**Coastal States
Energy Company**

RE: DETERMINATION OF COMPLETENESS, LEASE MODIFICATION,
SKYLINE MINE

Determination of Completeness Review Responses
Lease Modification
Skyline Mine
ACT/007/005
Carbon County, Utah

CHART 1

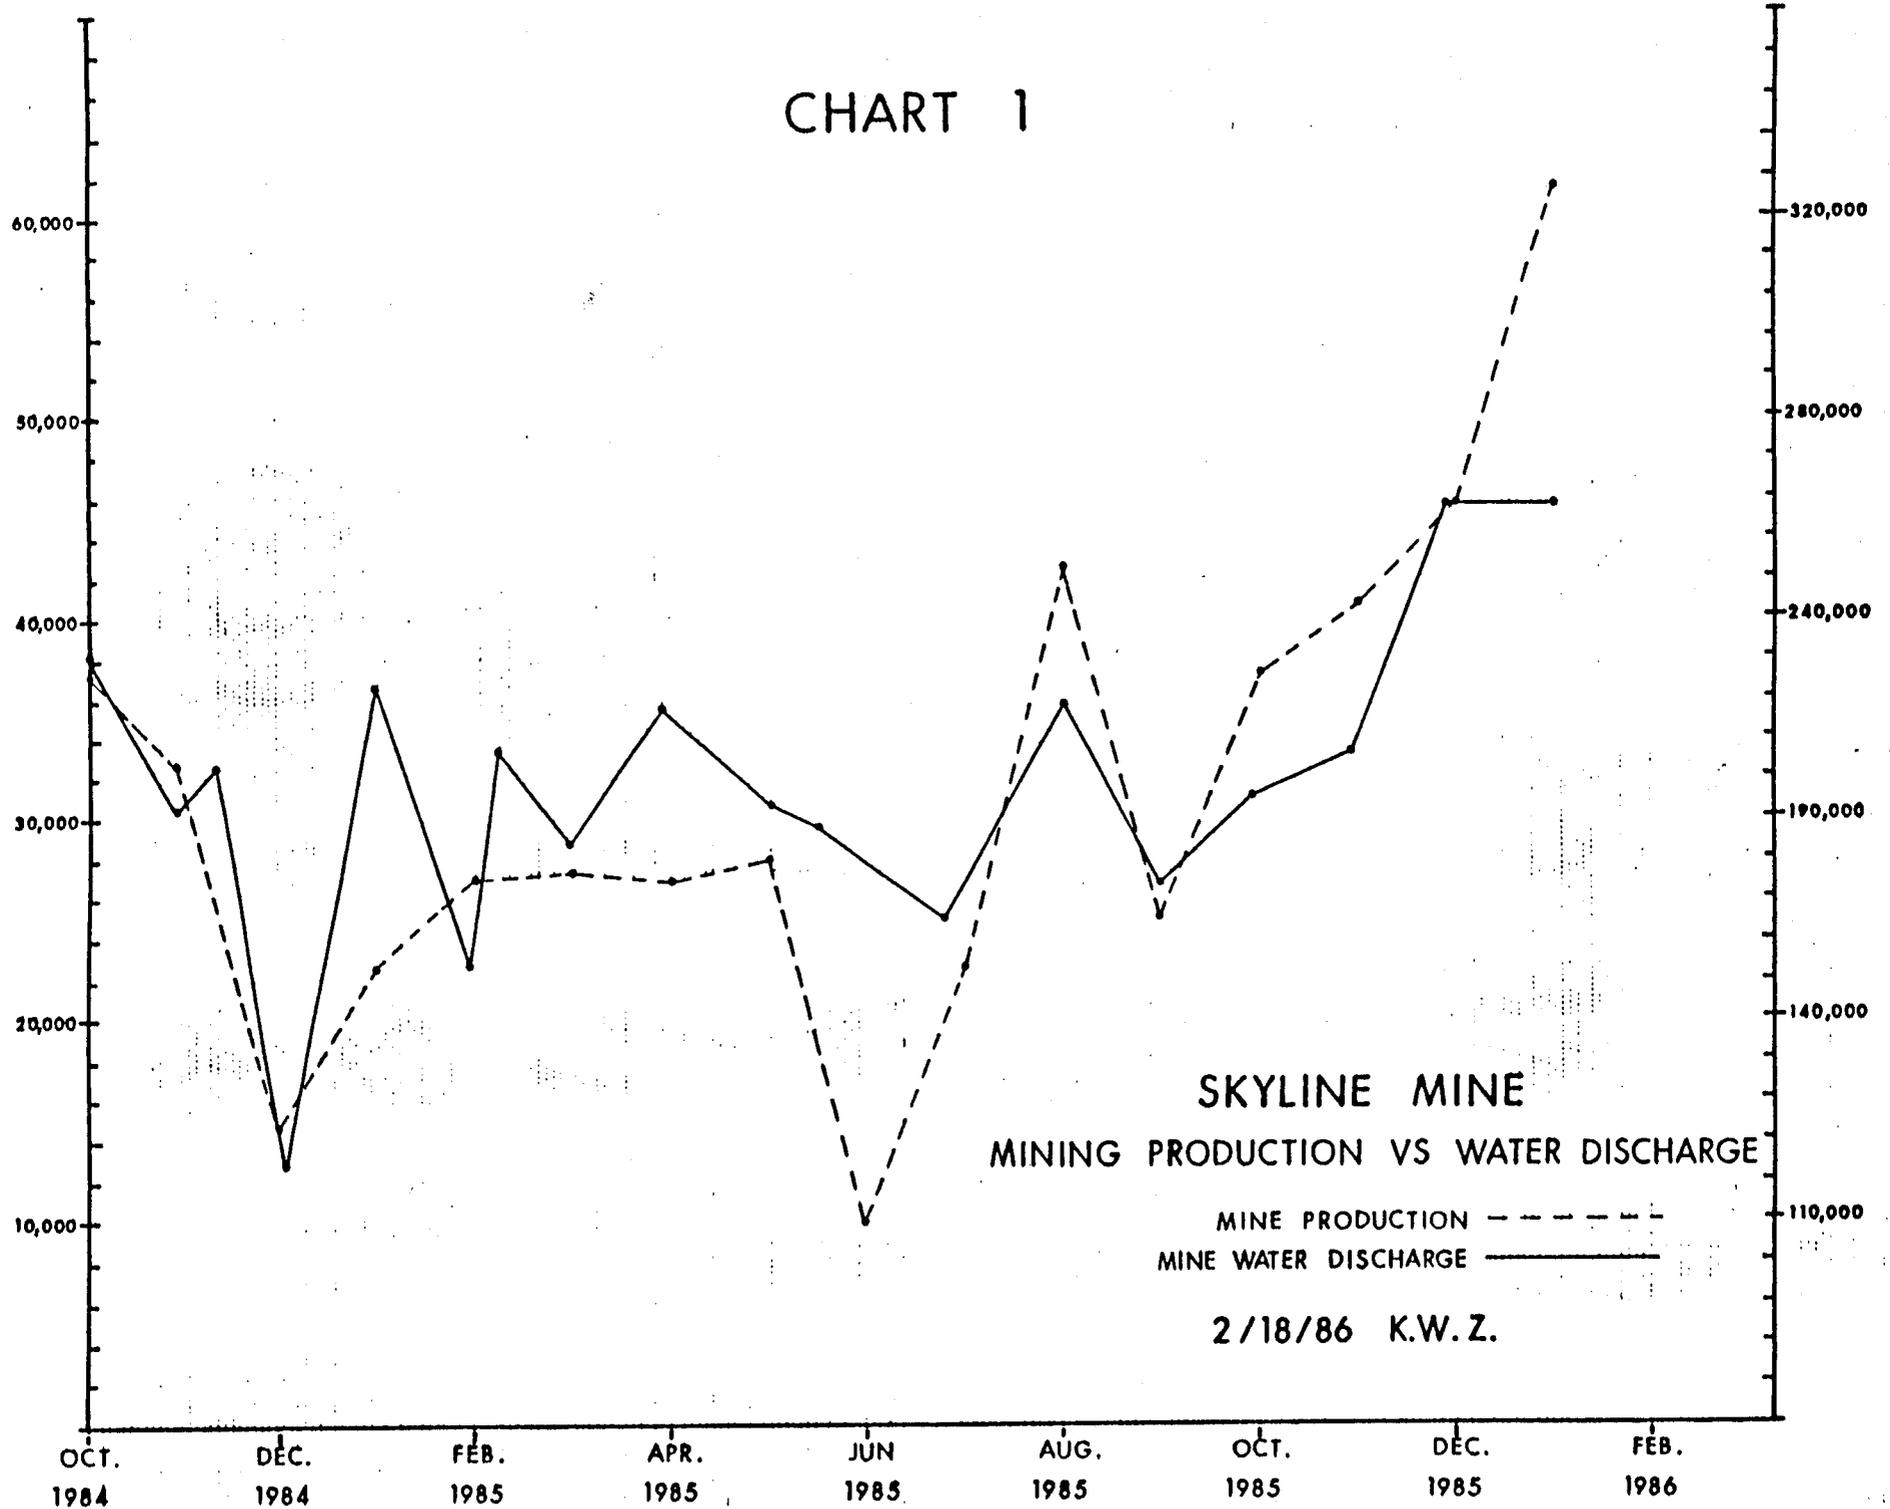
- (b)(2) A Narrative should be submitted describing any anticipated production of increased mine water and plans for treatment of that water (UMC 817.42).

The Skyline #3 Mine is currently pumping a monthly average of approximately 267,000 gallons per day of mine water discharge. There is a reasonably good correlation between the amount of mine water discharged and the amount of coal mined. This correlation is shown in Chart One, and we expect this trend to continue.
